HORSHAM DISTRICT COUNCIL CONSULTATION

TO:	Horsham District Council – Planning Dept
LOCATION:	Land to the South of Broadbridge Way Broadbridge Heath
DESCRIPTION:	Full Planning Application for the erection of 89no. residential dwellings comprising dwellings (54no.) and apartments (35no.), 36% affordable homes, creation of new vehicular access on to Sergeant Way, provision of public open space, landscaping and drainage solutions
REFERENCE:	DC/25/0894
RECOMMENDATION:	Holding objection / modification
RECOMMENDATION: 2nd Response in Red	Objection maintained, as modification is still needed to address Root Protection Area conflicts and concerns.
RECOMMENDATION: 3rd response in green	Advice / Holding objection withdrawn
SUMMARY OF COMMENTS & RECOMMENDATION: The submitted Arboricultural method statement and Tree protection plan are a fair assessment of the tree-related impacts of the development proposals at the site. However, some modification to the site layout is needed to address Root Protection Area conflicts and likely future resident pressure due to poor tree-to-build relationships post-development.

PROPOSED SITE LAYOUT showing the carpark to the north of T31 & T19

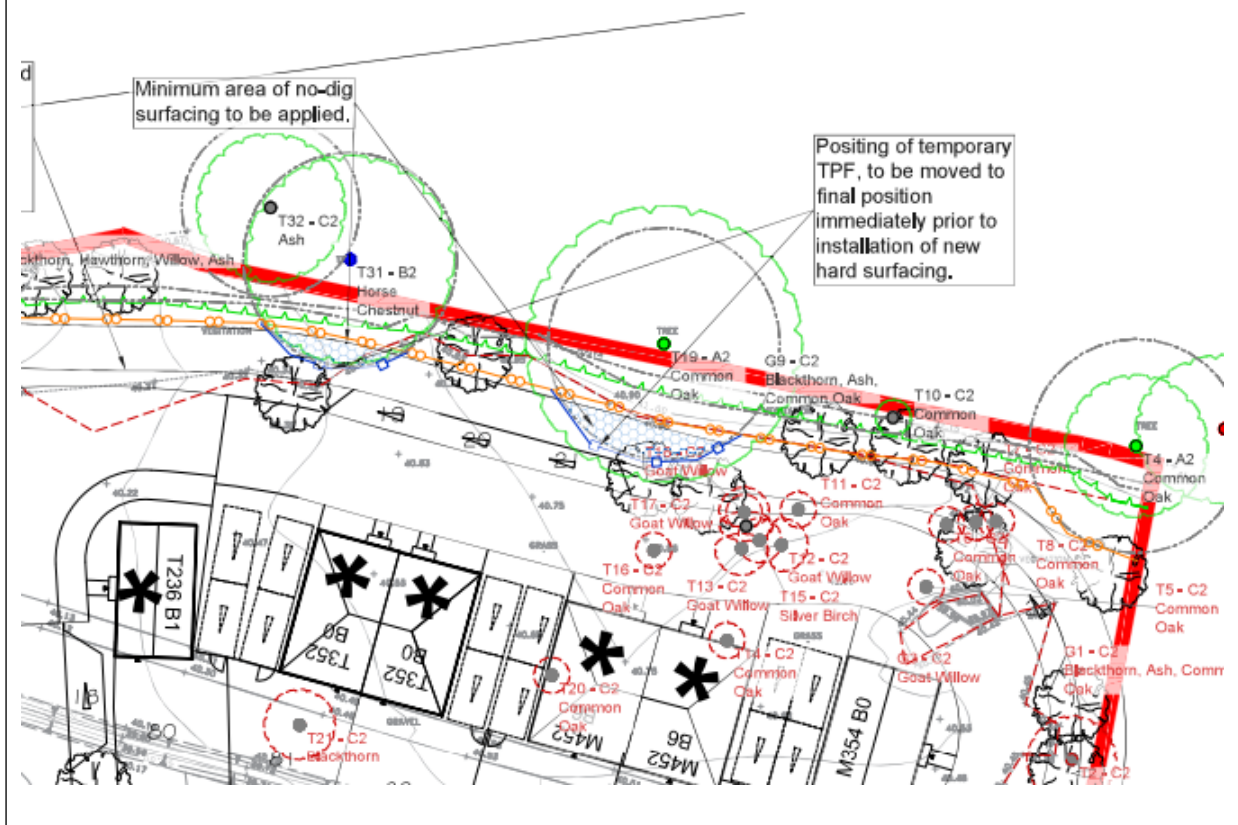
BS5837:2012 requires that where existing obstacles or surfaces constrain root development, the RPA should be amended to show where roots are most likely to occur. In this case, the off-site car park to the north of T31 and T19, which is clearly visible on the indicative site plan, has been omitted from the Tree Protection Plan. This results in a misleading representation of the trees' functional rooting environment and raises concern as to why this constraint has not been factored into the arboricultural assessment, particularly as it was raised in my previous response.

For both T31 and T19, nearly half of the theoretical RPA is currently shown extending beneath an impermeable car park surface to the north. This means that any additional encroachment into the remaining functional (southern) portion of the RPA becomes significantly more critical. As such, based on the current assessment the proposed cycle path, to the south of the trees, in particular, would in my opinion, increase development within the RPA as is currently shown well beyond the 20% threshold generally accepted within BS5837, further exacerbating non-compliance with the BS.

Tree Protection Plan DWG NO: VYH24657-03A Sheet 2 of 2. It should be noted that the date on the new TPP has not been updated from the 17/04/2025 submission, despite the plans and site layout having been altered.

Given the likely southward rooting bias for T31 and T19, caused by the existing hardstanding, the proposed new road to the south is expected to lie partially or wholly within the functional RPAs of T31 and T34. No mitigation measures have been proposed to address this conflict. As such, the scheme is not considered to be compliant with BS5837 and is likely to result in significant, delayed-onset harm to these trees over the next 5–10 years, due to construction activity and root loss/damage within their key rooting areas, unless the layout is amended accordingly.
